# **Noise Feasibility Study**

## **Proposed Residential Development**

### **Wyndham Street and Main Street**

As requested, we have prepared the following supplementary information regarding the Noise Feasibility Study, for the proposed residential development located at Wyndham Street and Main Street, in response to comments received by the City of Mississauga's Planning and Building Department.

**Figure 2: Proposed Site Plan**

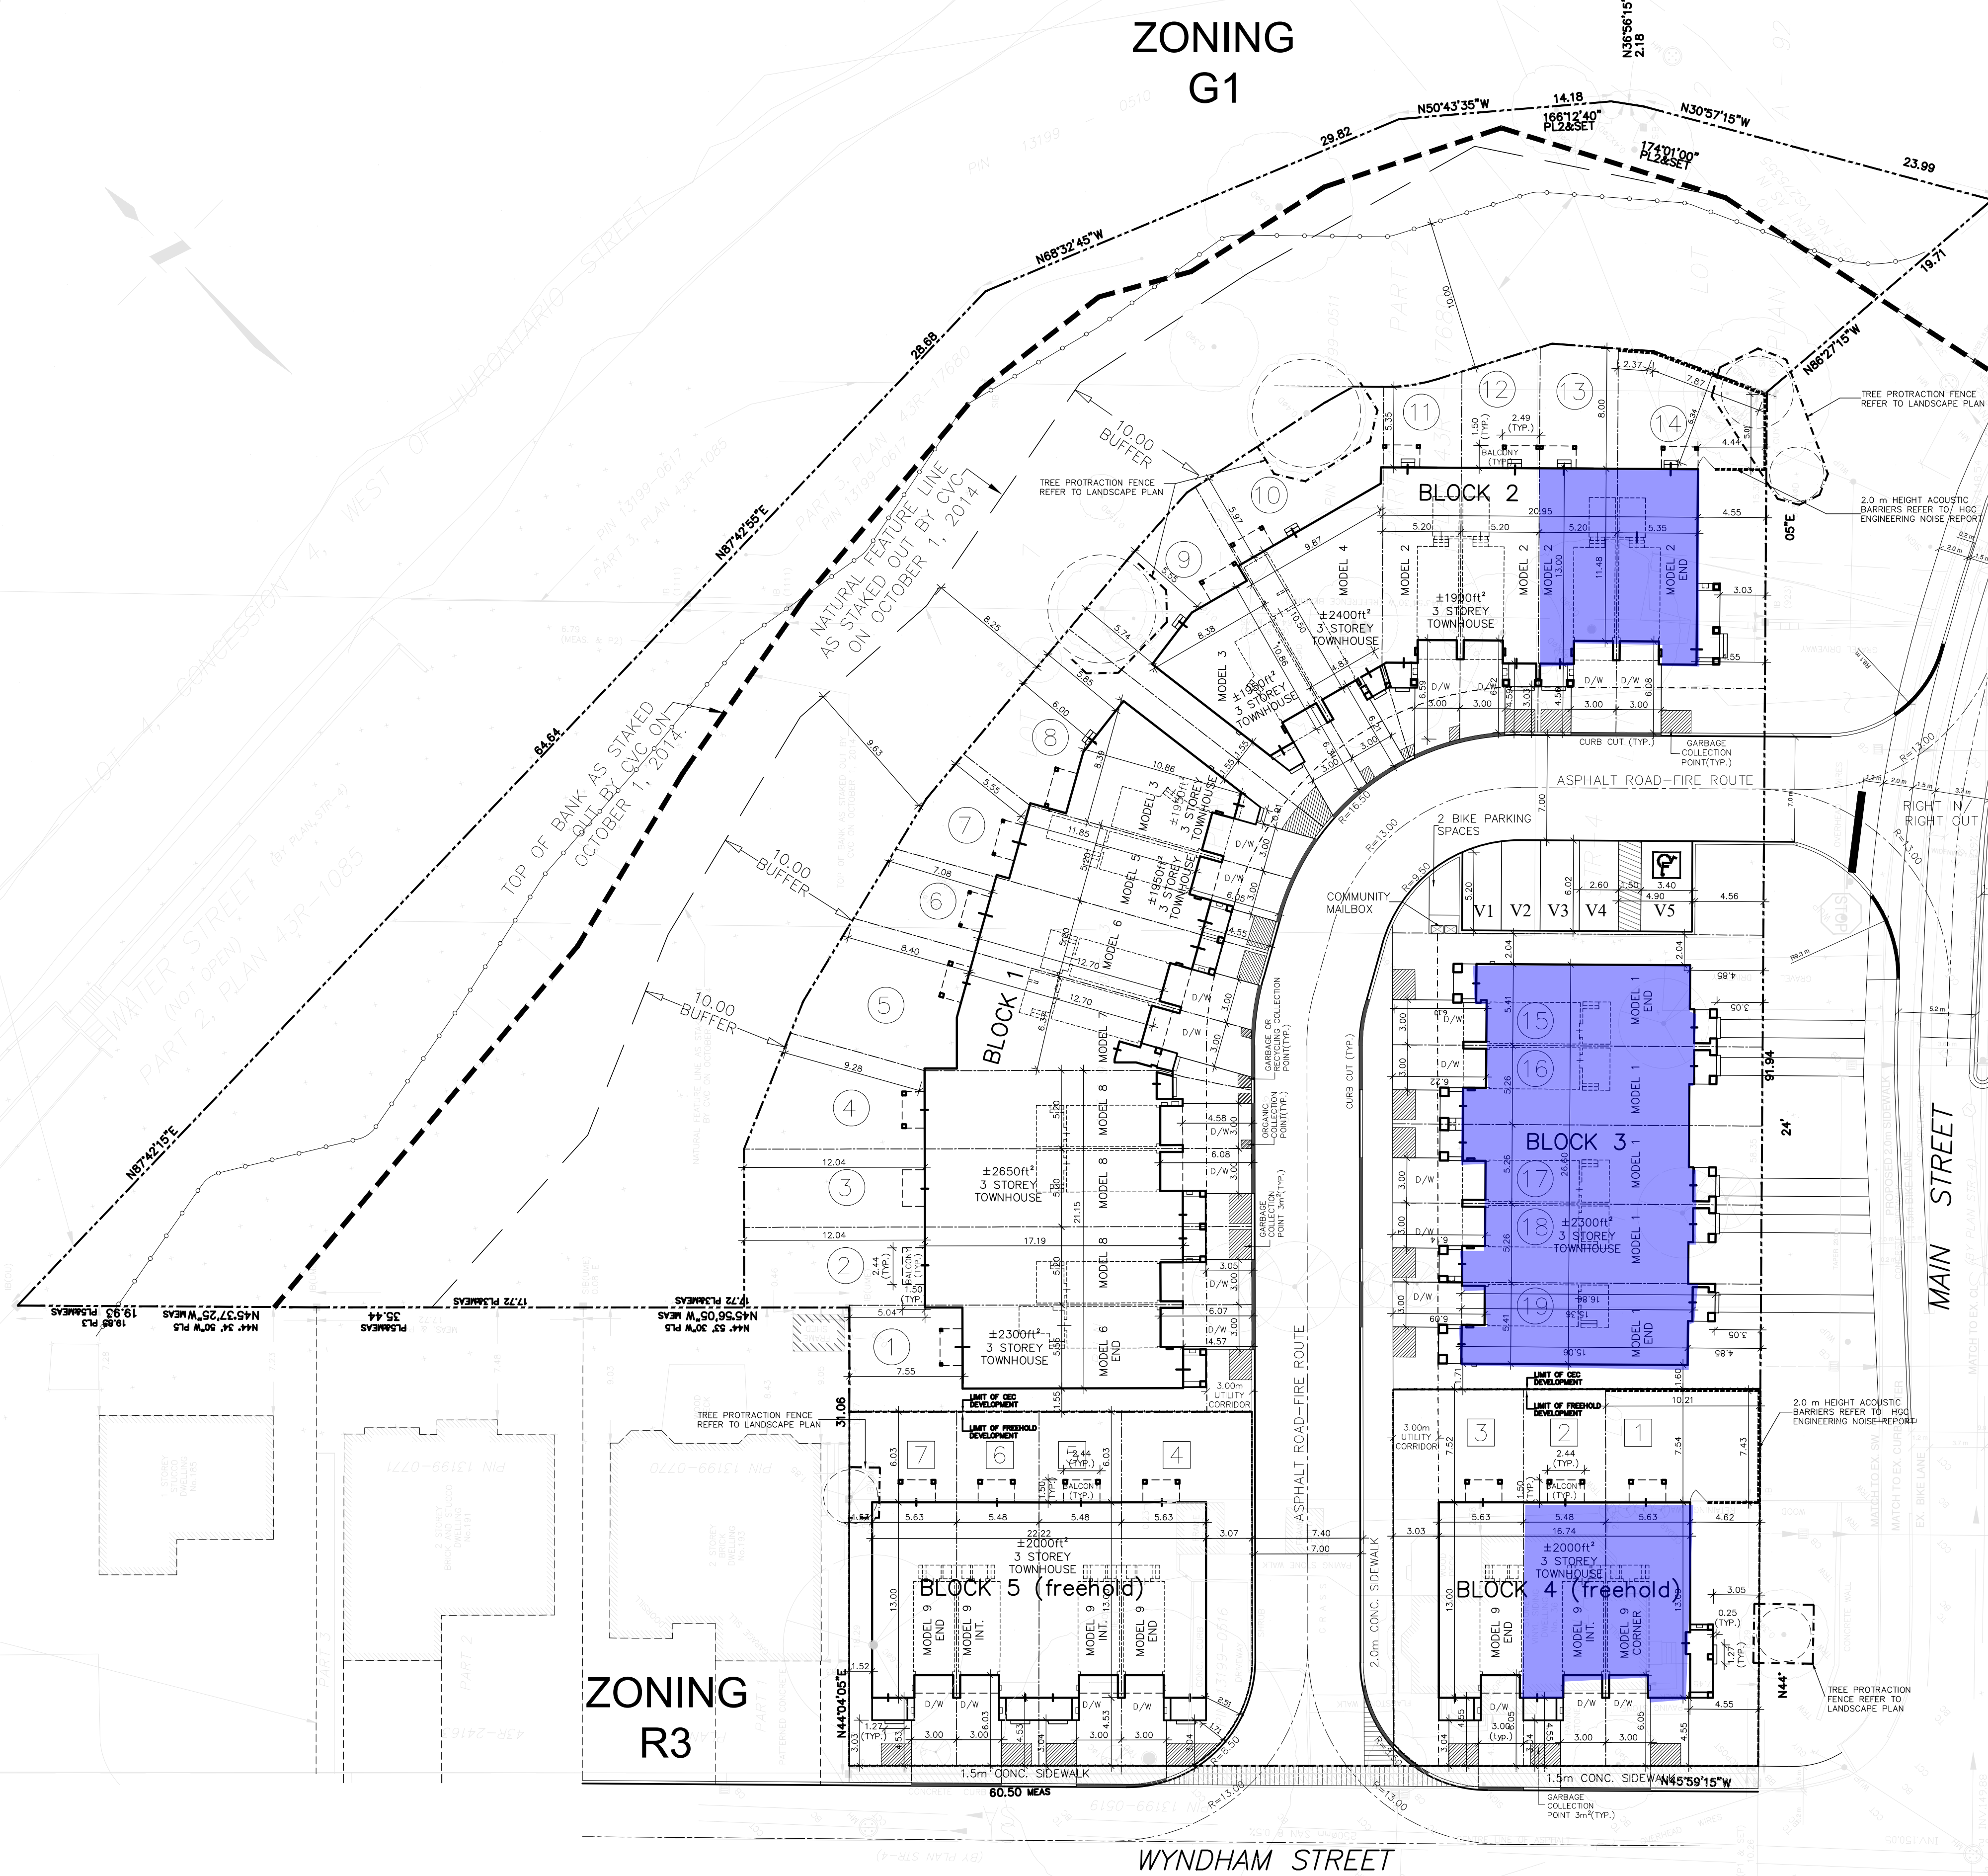
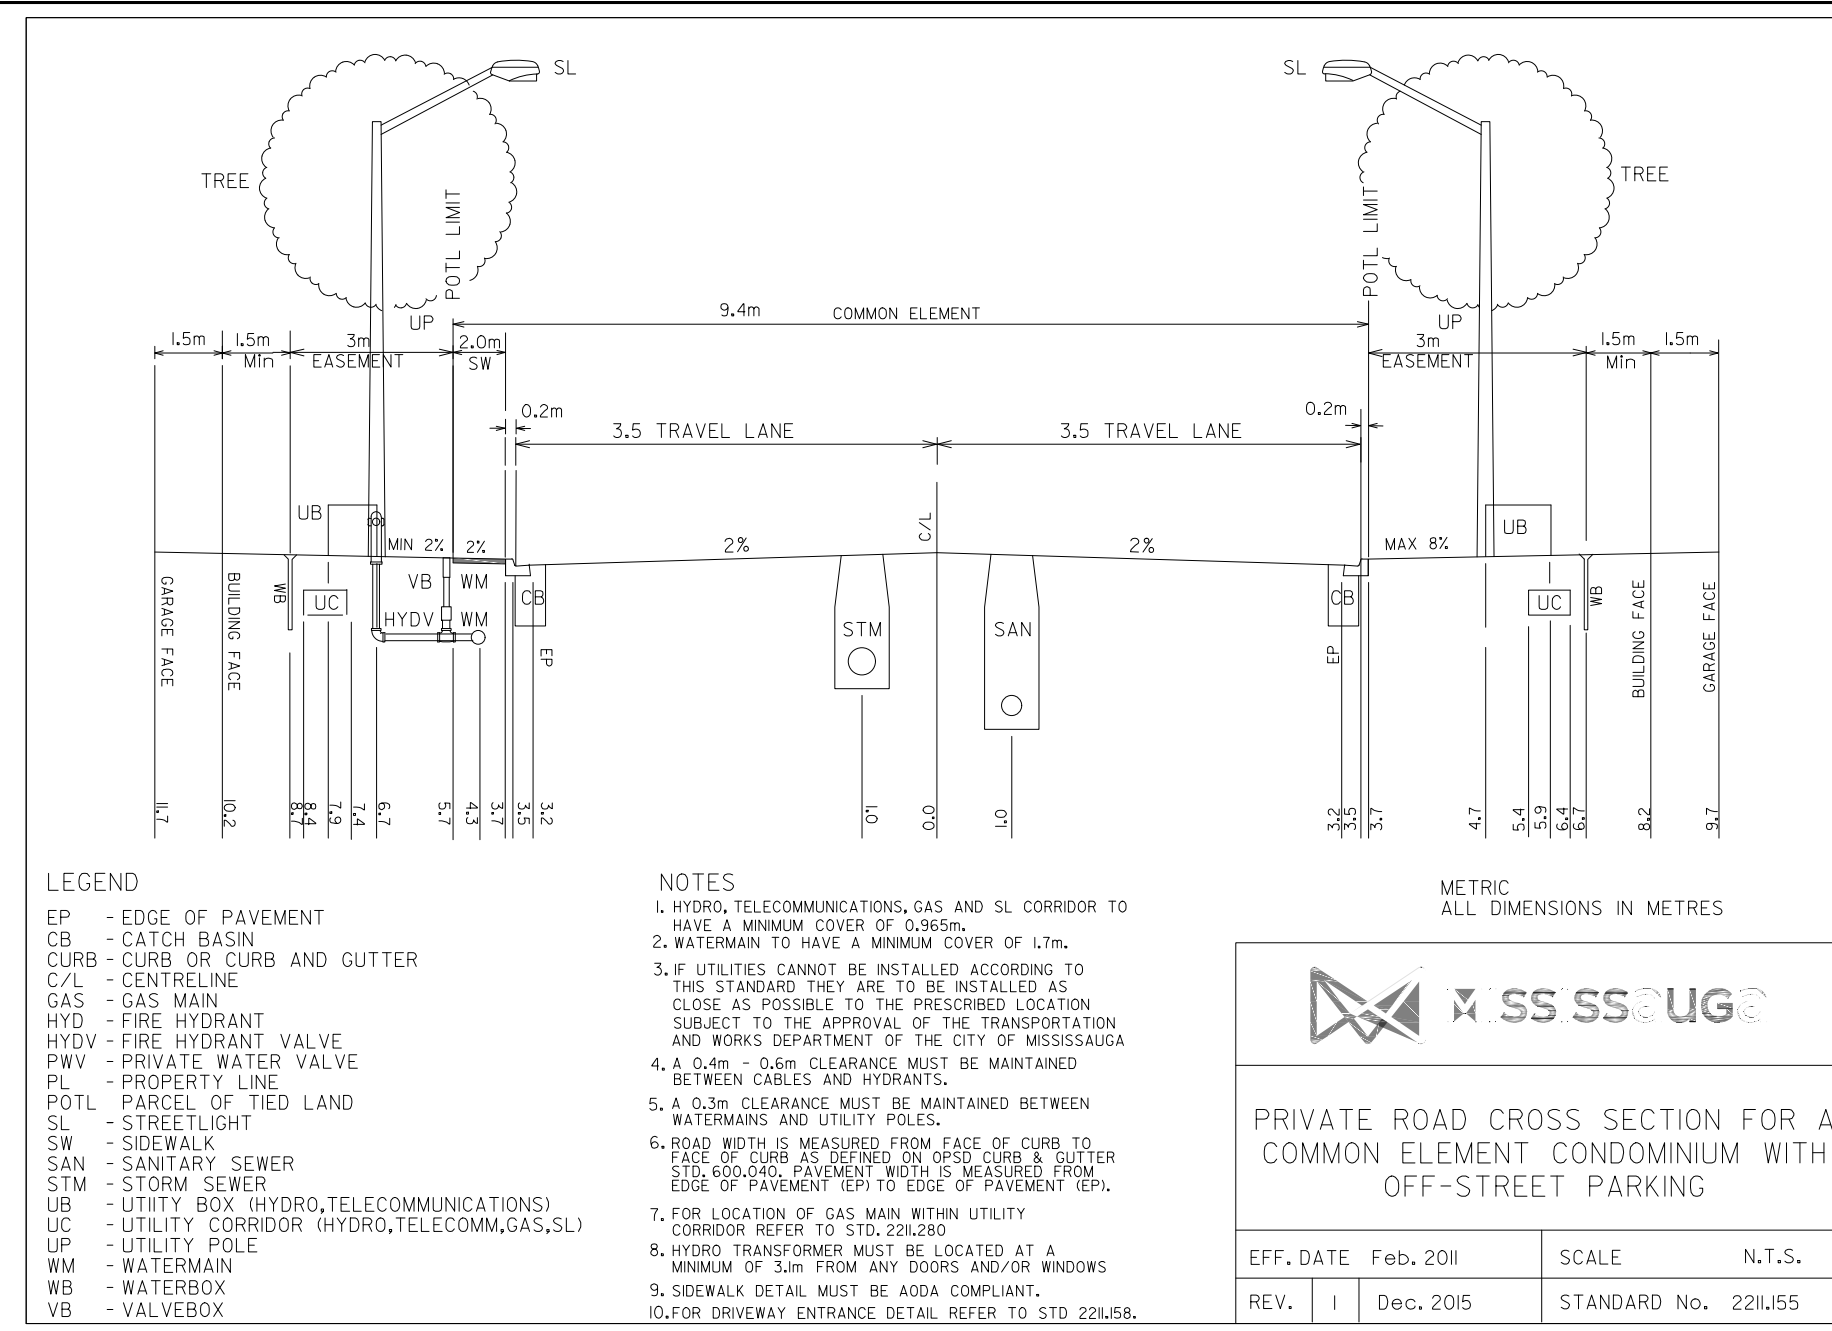
14. Updated June 06/2019 comment remains: The updated noise study has not been received with this submission. Acoustic fences along Main Street should be setback to 3.0 meters matching the townhouse porches. Acoustic fences should not project past the front porch of the townhouses of Block 1 (Freehold) and Block 2 (CEC). Amend the noise study to reflect these changes.

Per comments from civil engineering, the acoustical fence setback cannot be revised. The planned fence setback is as is to allow for a stormwater pipe easement.

Please see revised the site plan.
